# Site Accessibility Evaluation

## Americans with Disabilities Act Title II (Public Services: State and Local Government)

### **Motor Vehicle East**

**5650 Industrial Pl  
Colorado Springs, CO  
80916**

### Finding: 1

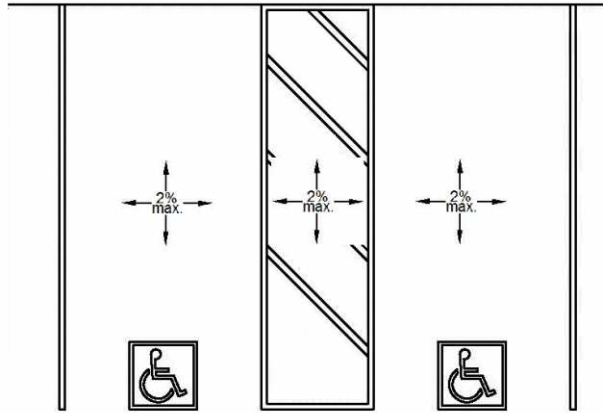
The cross slopes (narrow dimension) and/or running slopes (long dimension) of the access aisle exceeds 2%.

Cross slopes range  
from 4% to 4.5%

Recommend re-paving just the area that will contain accessible parking stalls to include van and car accessible stalls and access aisles.

### Finding: 4

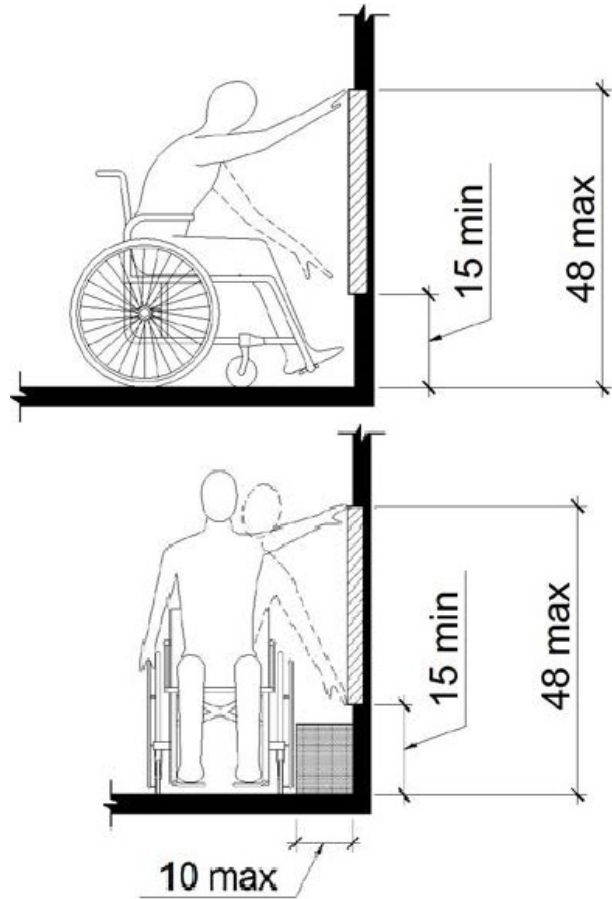
The baby changing table operating mechanism is outside reach range.  
The maximum high reach allowed is 48 inches

55.5 above finished  
floor

Remove and replace existing baby changing station with a horizontal station. Ensure there is a 27 inch minimum knee clearance measured from the finished floor to the bottom edge of the baby changing station, 28 inches minimum to 34 inches maximum to the top of the table surface and the operable part at a maximum of 48 inches measured from the finished floor.

### Finding: 5

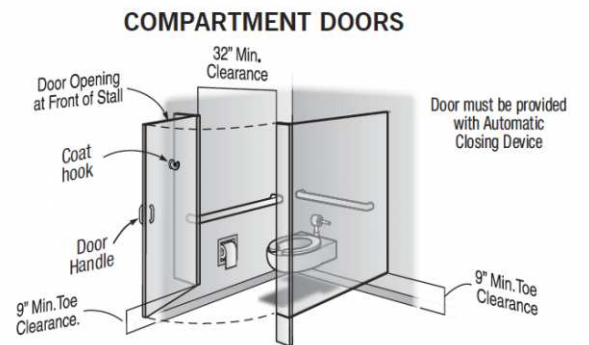
The compartment door is not self closing.

Not self closing

Adjust or install automatic closing hinges.

### Finding: 6

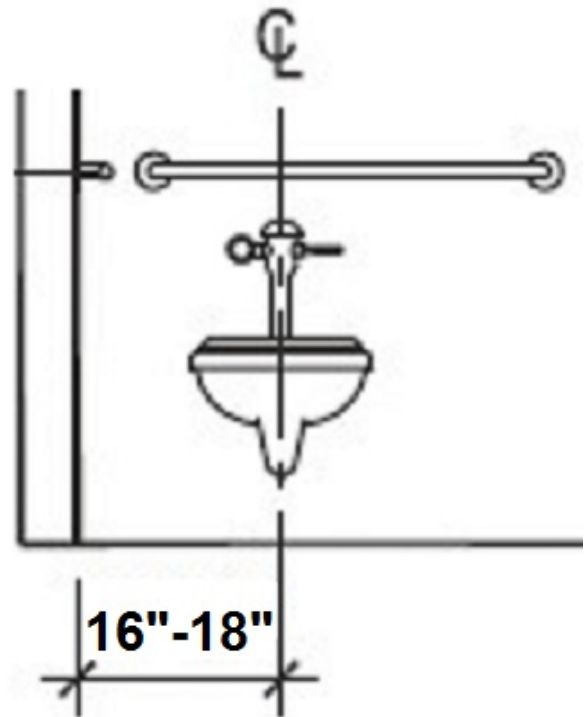
The toilet is not located within the range allowed from the side wall or partition.

18.5 inches from side wall

Re-position toilet between 16 inches minimum and 18 inches maximum from centerline of toilet to side wall. May require plumbing alteration.

### Finding: 7

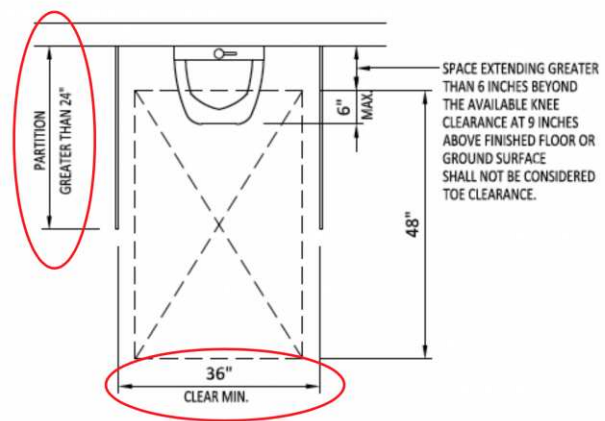
The urinal is confined on three sides (alcove).

34.5 inches wide

If possible and if space permits, readjust partition 1.5 inches to meet compliance at 36 inches wide minimum.

### Finding: 8

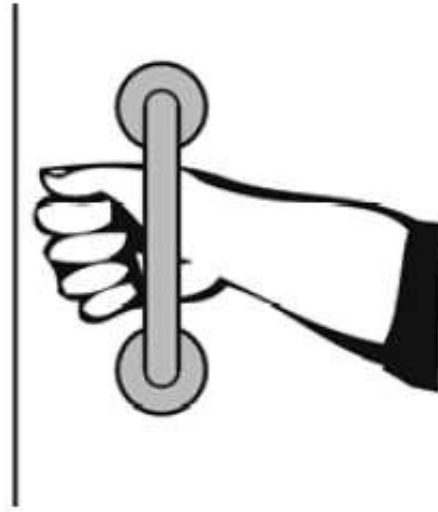
The water closet compartment door is missing a loop handle on the inside.

Missing loop handle  
on the inside

Install loop handle on inside of compartment door.

### Finding: 9

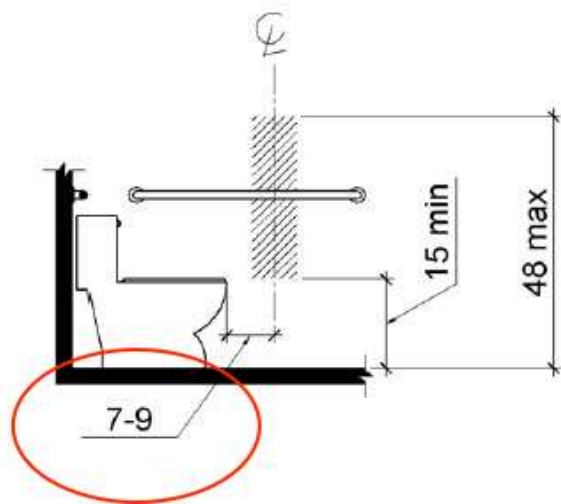
The toilet paper is not installed within the compliant range in front of the toilet.

2 inches from the front  
of the toilet

Re-position toilet paper dispenser to be within 7 inches minimum to 9 inches maximum in front of the toilet measured to the centerline of the toilet paper dispenser.

### Finding: 10

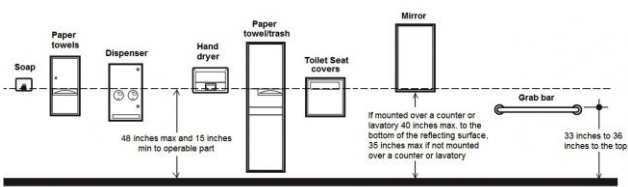
The toilet seat cover dispenser is mounted too high.

55 inches above  
finished floor

Relocate seat cover dispenser to have operable part between 15 inches minimum and 48 inches maximum above floor. May require relocation below rear or side grab bar at 1.5 inches minimum clearance below grab bar to meet compliance.

### Finding: 11

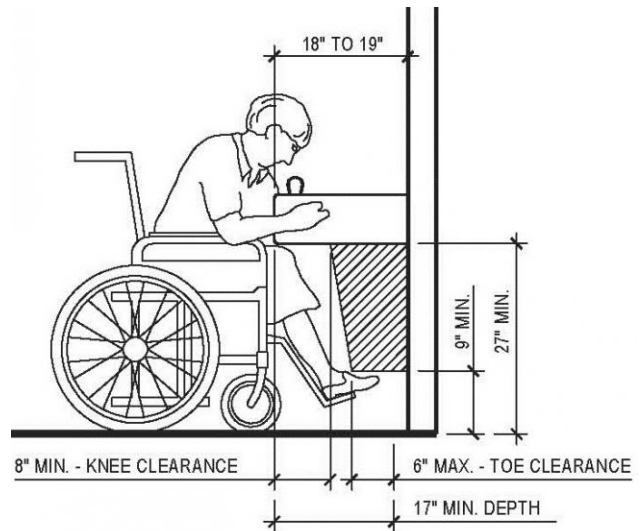
There is not enough knee clearance under the drinking fountain.

26.5 inches above  
finished floor

Re-position drinking fountain half an inch up to ensure knee space of 27 inches minimum above finished floor.

### Finding: 12

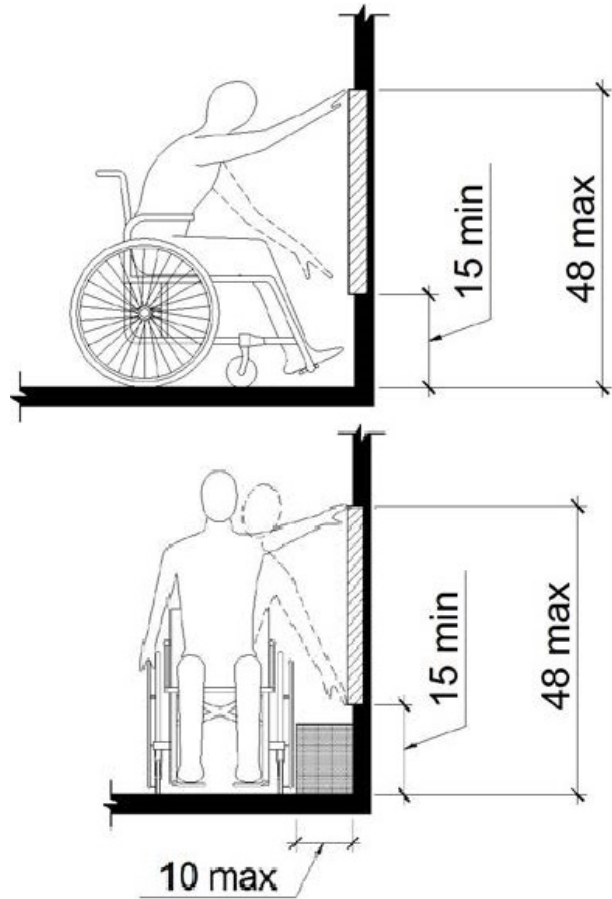
The baby changing table operating mechanism is outside reach range.  
The maximum high reach allowed is 48 inches

55 inches above  
finished floor

Remove and replace existing baby changing station with a horizontal station. Ensure there is a 27 inch minimum knee clearance measured from the finished floor to the bottom edge of the baby changing station, 28 inches minimum to 34 inches maximum to the top of the table surface and the operable part at a maximum of 48 inches measured from the finished floor.

### Finding: 13

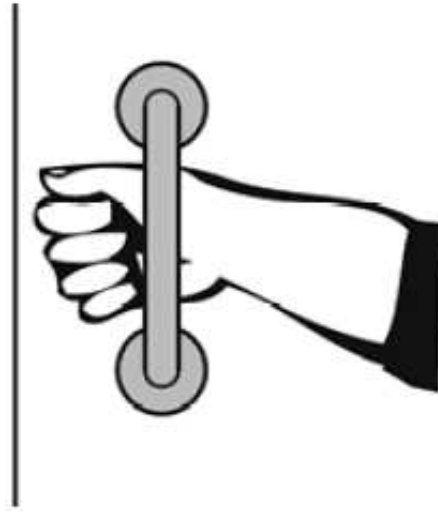
The water closet compartment door is missing a loop handle on the inside.

Missing loop handle

Install loop handle on inside of compartment door.

### Finding: 14

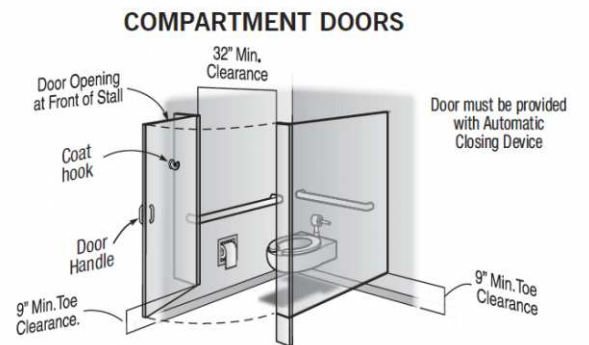
The compartment door is not self closing.

Not self closing

Adjust or install automatic closing hinges.

### Finding: 15

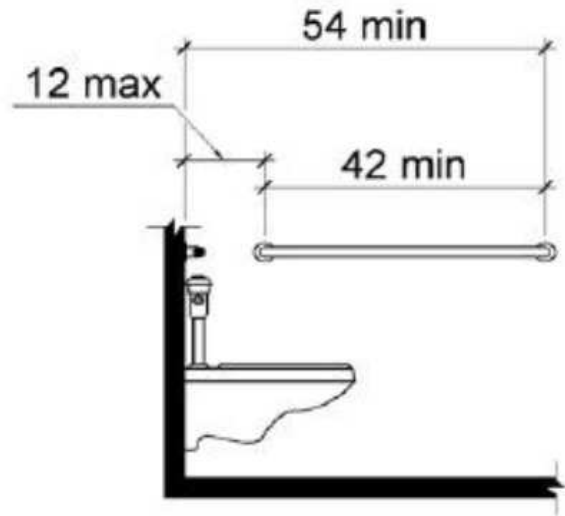
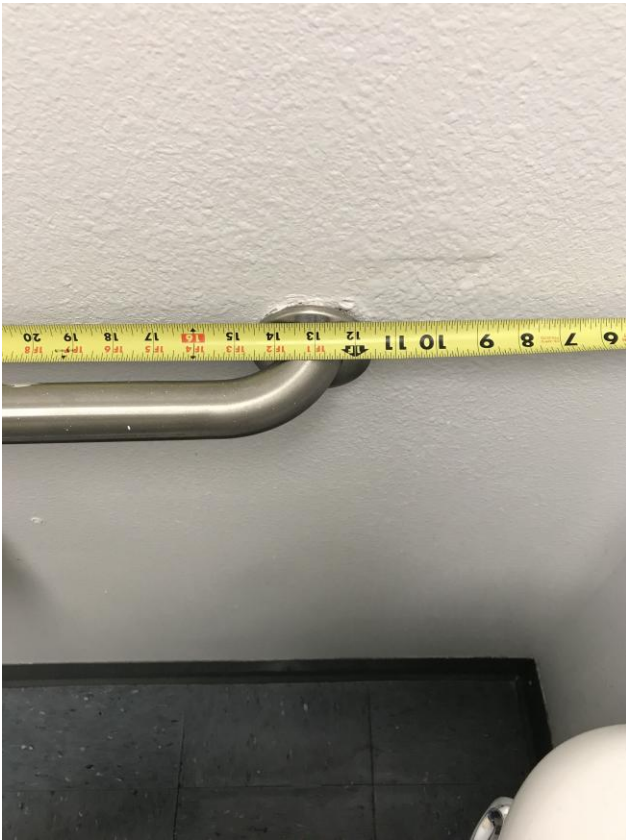
The side grab bar is located greater than 12 inches from the rear wall.

13 inches from rear wall

Adjust side grab bar not to exceed 12 inches from rear wall. The side grab bar must be 42 inches minimum in length and extend at least 54 inches minimum beyond the rear wall.

### Finding: 16

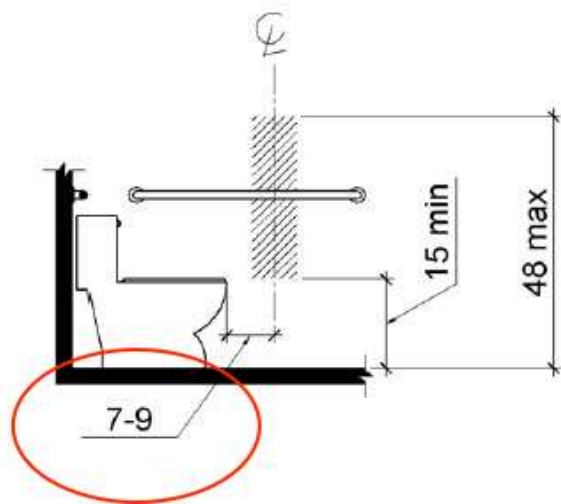
The toilet paper is not installed within the compliant range in front of the toilet.

1 inch from the front of  
the toilet

Re-position toilet paper dispenser to be within 7 inches minimum to 9 inches maximum in front of the toilet measured to the centerline of the toilet paper dispenser.

### Finding: 17

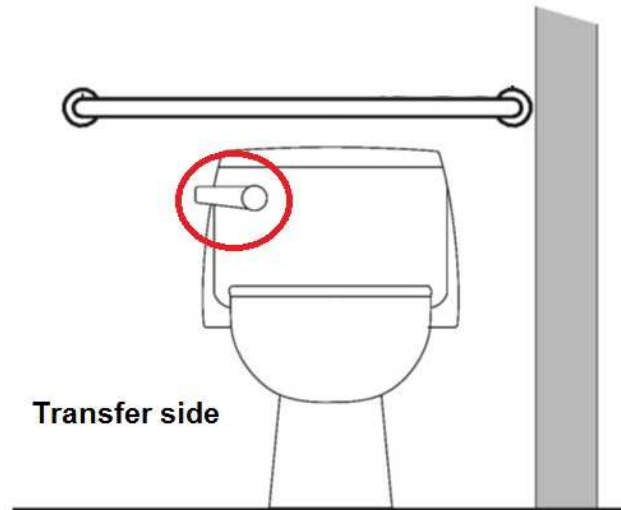
The flush handle is located on the wrong side of the toilet.

Flush handle located  
on closed side

Replace toilet water tank with one that has flush handle on the opposite side (open side of toilet area).

### Finding: 18

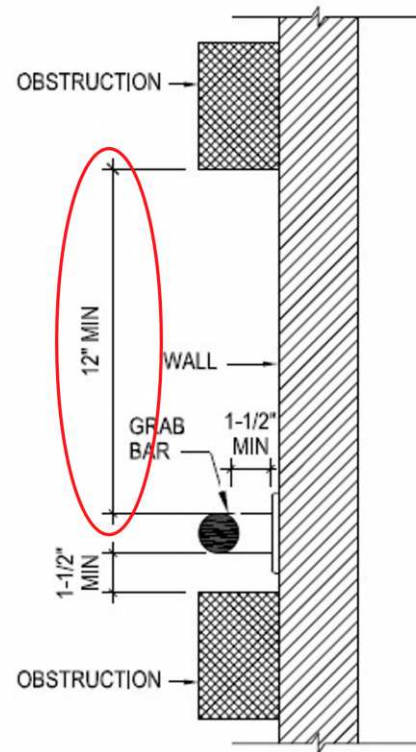
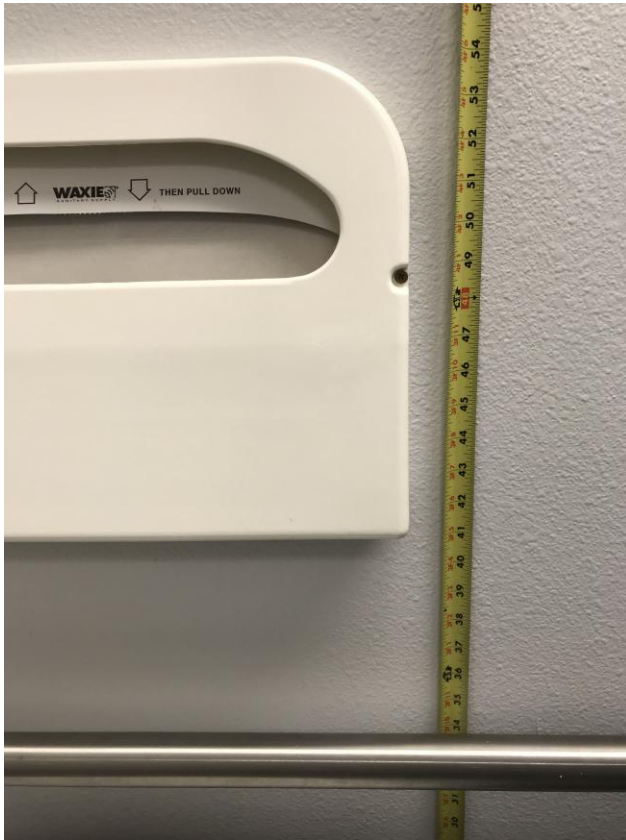
The seat cover dispenser is positioned too close to the grab bar.

7 inches above rear  
grab bar

Relocate seat cover dispenser to have operable part between 15 inches minimum and 48 inches maximum above floor. May require relocation below rear or side grab bar at 1.5 inches minimum clearance below grab bar to meet compliance.

### Finding: 19

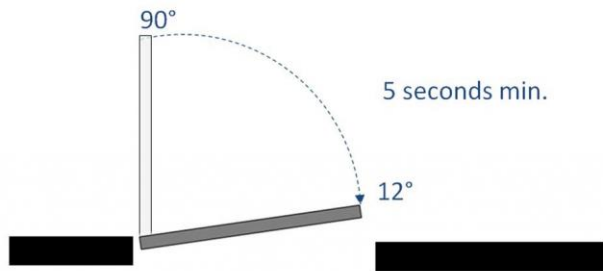
The door is equipped with a door closer and returns to a closed position too quickly.

2 seconds to closed position

Adjust door closer to allow a minimum of 5 seconds to move from the open position at 90 degrees to 12 degrees from the latch/locking mechanism.

### Finding: 20

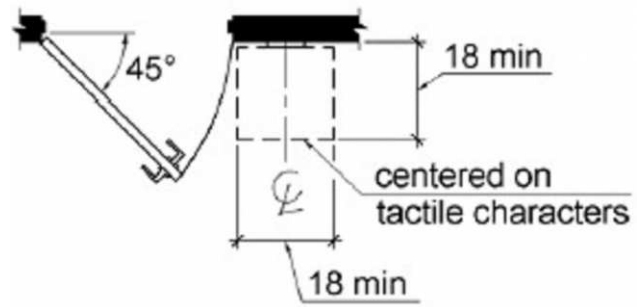
Clear floor space is not provide at the tactile door sign.

6 inches beyond door swing

Reposition sign 3 inches to the right to provide the required clear floor space in front of sign. Sign should measure 9 inches to centerline.

### Finding: 21

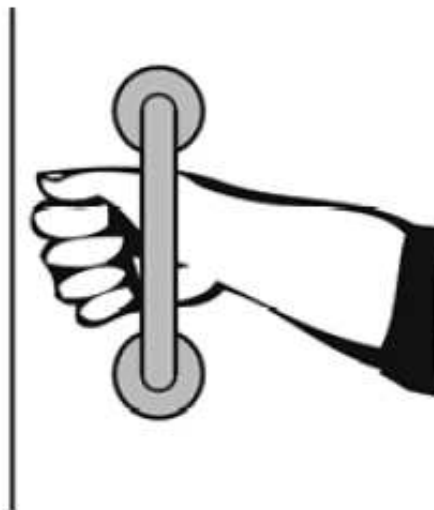
The water closet compartment door is missing a loop handle on the inside.

Missing inside loop handle

Install loop handle on inside of compartment door.

### Finding: 22

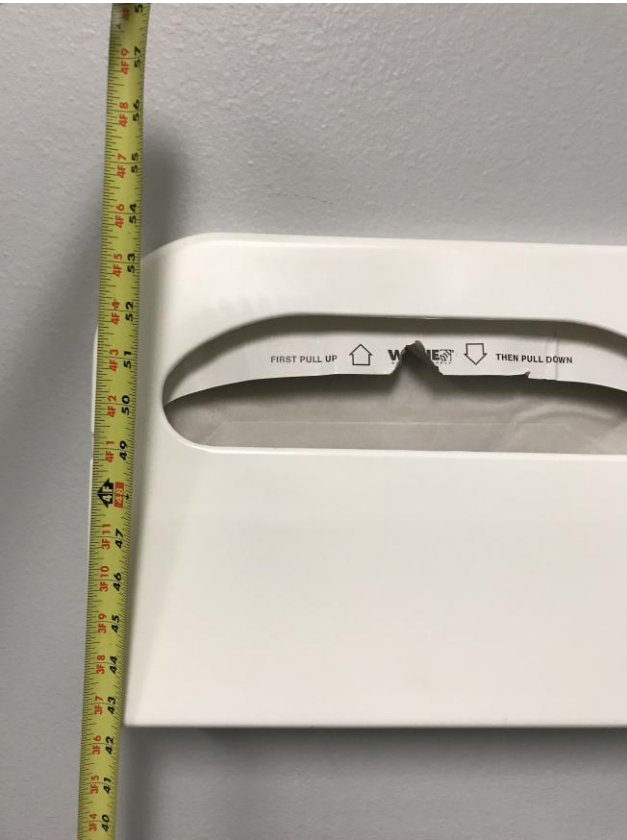
The toilet seat cover dispenser is mounted too high.

50 inches above  
finished floor

Relocate seat cover dispenser to have operable part between 15 inches minimum and 48 inches maximum above floor. May require relocation below rear or side grab bar at 1.5 inches minimum clearance below grab bar to meet compliance.

### Finding: 23

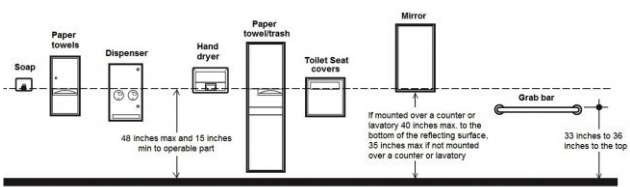
The paper towel dispenser's operation mechanism is too high off the floor.

51 inches above  
finished floor

Lower paper towel dispenser 3 inches to meet compliance. 48 inches maximum height above finished floor for operable parts (sensor).

### Finding: 25

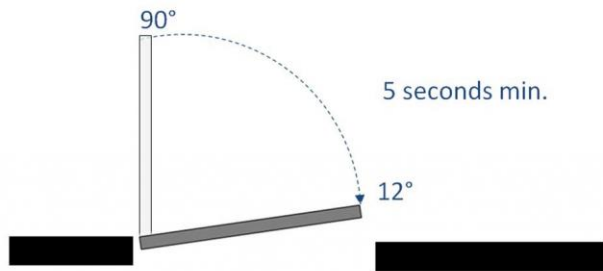
The door is equipped with a door closer and returns to a closed position too quickly.

4 seconds to closed position

Adjust door closer to allow a minimum of 5 seconds to move from the open position at 90 degrees to 12 degrees from the latch/locking mechanism.
